**1600 HAMPTON ANNEX – RENOVATION (DLES)**

**PROJECT NO: H27-I997**  
**USC PROJECT NO: CP00345233**  
**JCS PROJECT NO: 12113**

**ADDENDUM 02**  
**April 3, 2014**

**DEMOLITION PLAN - BASEMENT**

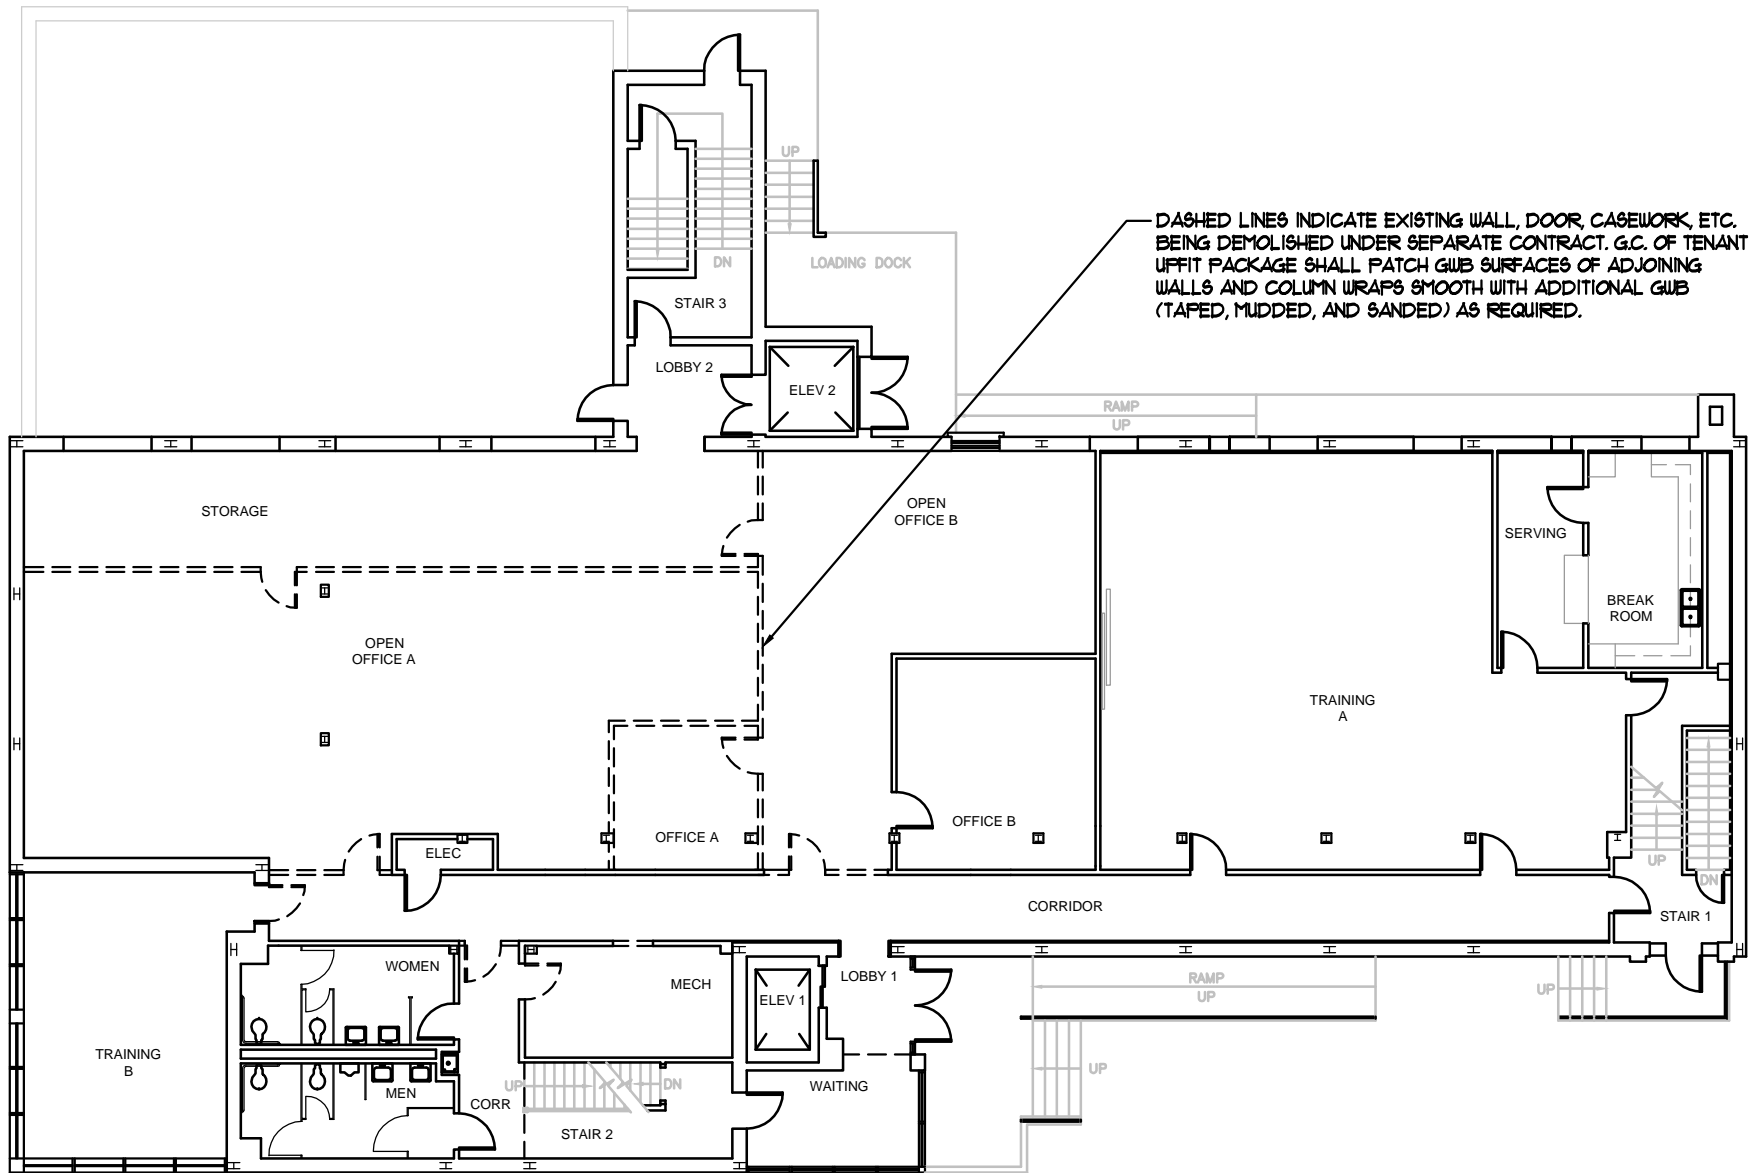
1. Revise bid closing date, as listed on the SE-310 Request for Advertisement, to **4/9/2014** at 2:00 pm.
2. See attached demolition plans from previous Deferred Maintenance bid package (demolition shown for information only). Dashed lines indicate existing wall, door, casework, etc. being demolished under Deferred Maintenance contract. G.C. of this renovation package shall patch GWB surfaces of adjoining walls and column wraps smooth with additional GWB (taped, mudded, and sanded) as required. Demolition Plan sheets D100, D101, and D102 of this renovation package shall still apply.

**DEMOLITION PLAN - 1ST FLOOR**

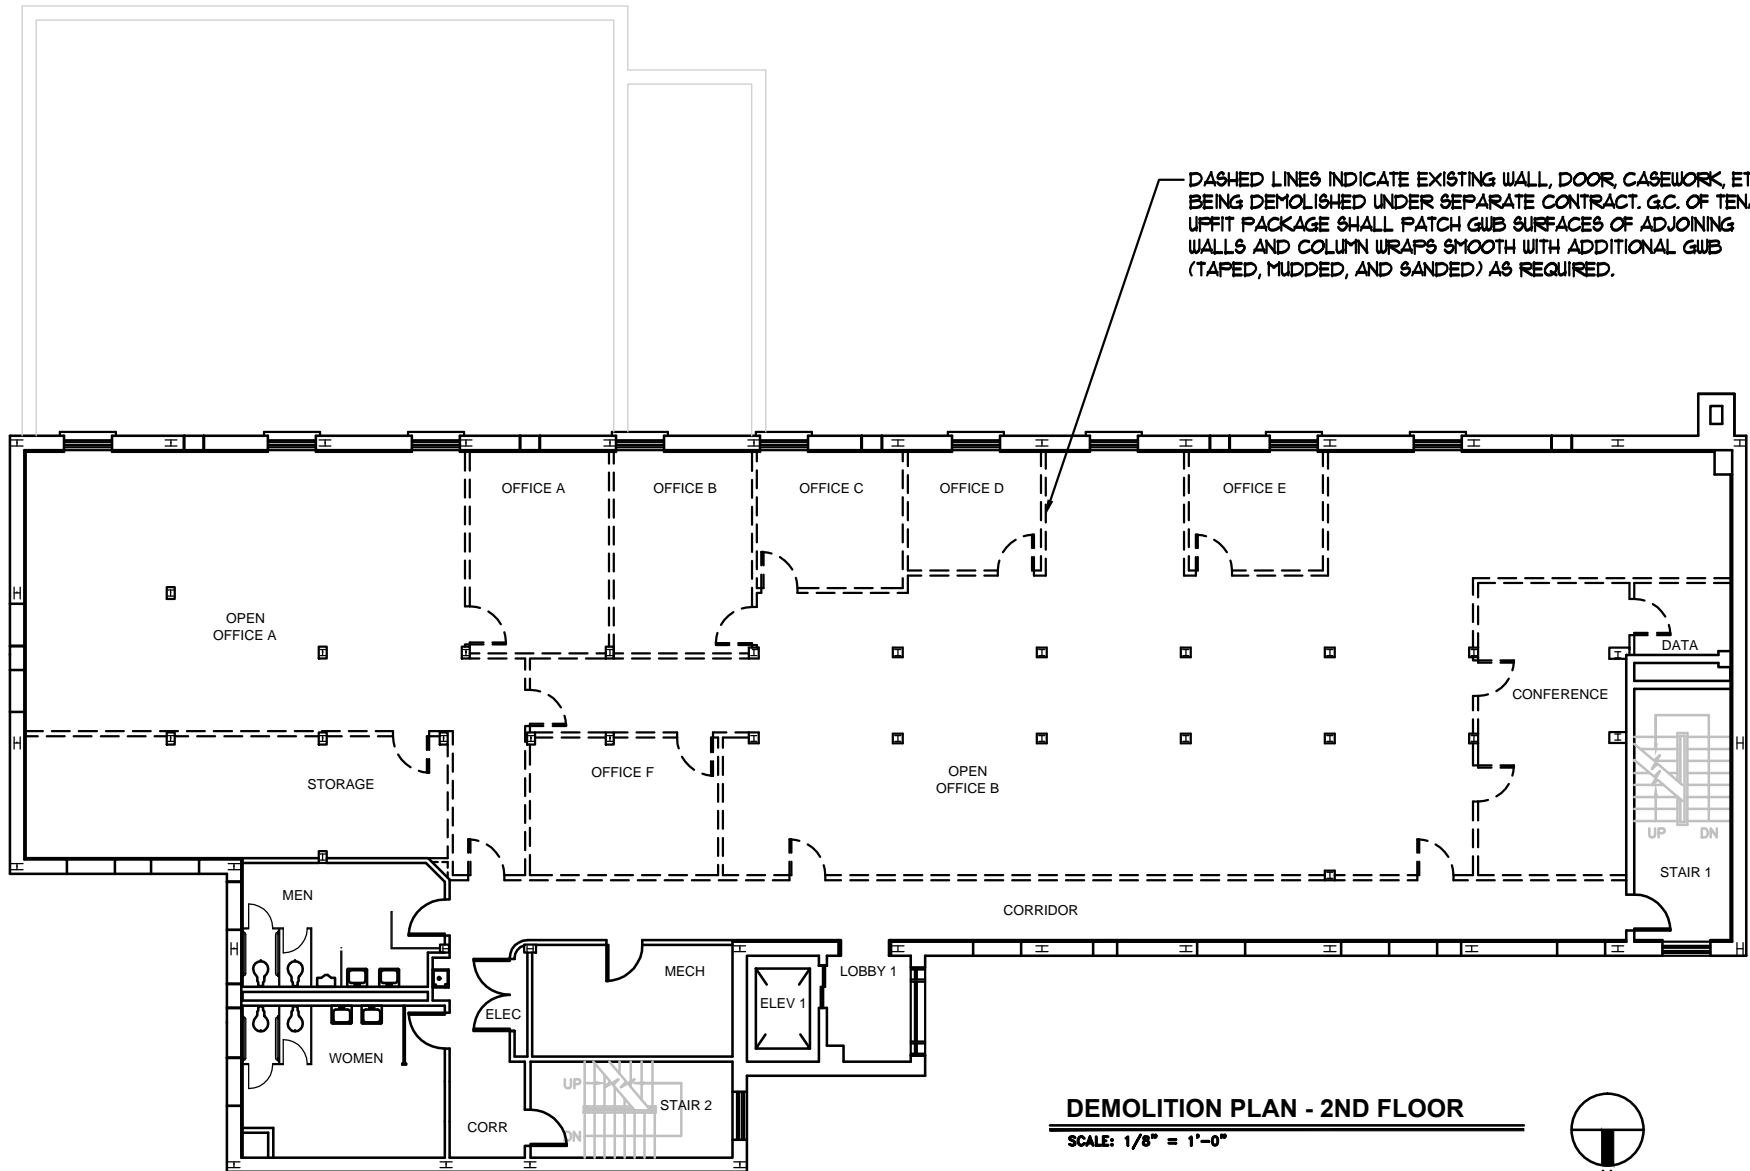
DASHED LINES INDICATE EXISTING WALL, DOOR, CASEWORK, ETC. BEING DEMOLISHED UNDER SEPARATE CONTRACT. G.C. OF TENANT UFFIT PACKAGE SHALL PATCH GUB SURFACES OF ADJOINING WALLS AND COLUMN WRAPS SMOOTH WITH ADDITIONAL GUB (TAPED, MUDDERED, AND SANDED) AS REQUIRED.

**DEMOLITION PLAN - 2ND FLOOR**

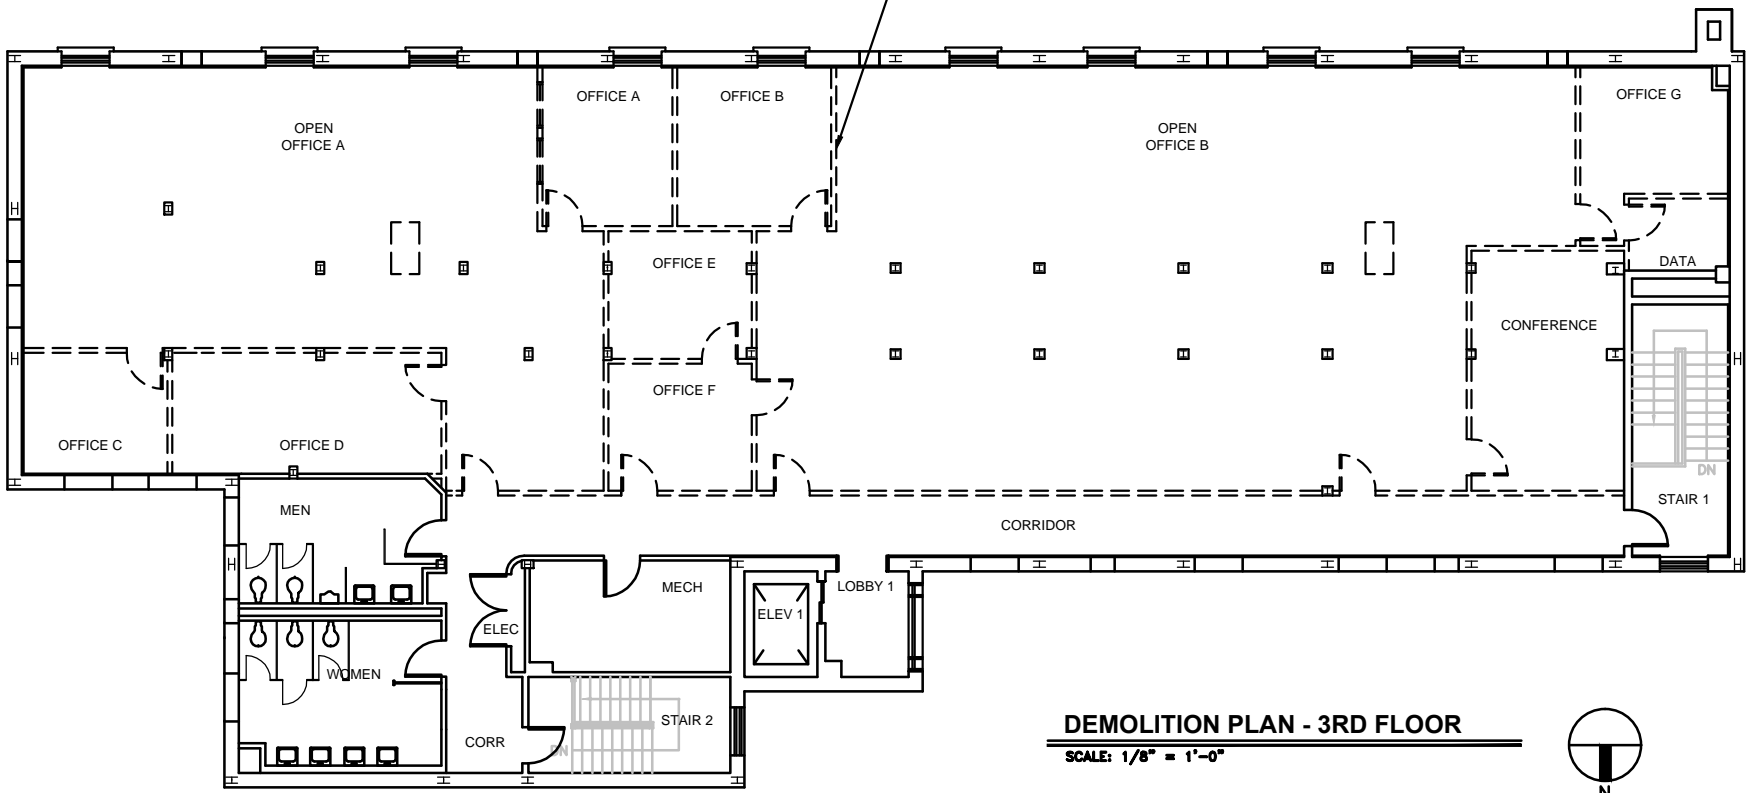
DASHED LINES INDICATE EXISTING WALL, DOOR, CASEWORK, ETC. BEING DEMOLISHED UNDER SEPARATE CONTRACT. G.C. OF TENANT UFFIT PACKAGE SHALL PATCH GUB SURFACES OF ADJOINING WALLS AND COLUMN WRAPS SMOOTH WITH ADDITIONAL GUB (TAPED, MUDDERED, AND SANDED) AS REQUIRED.
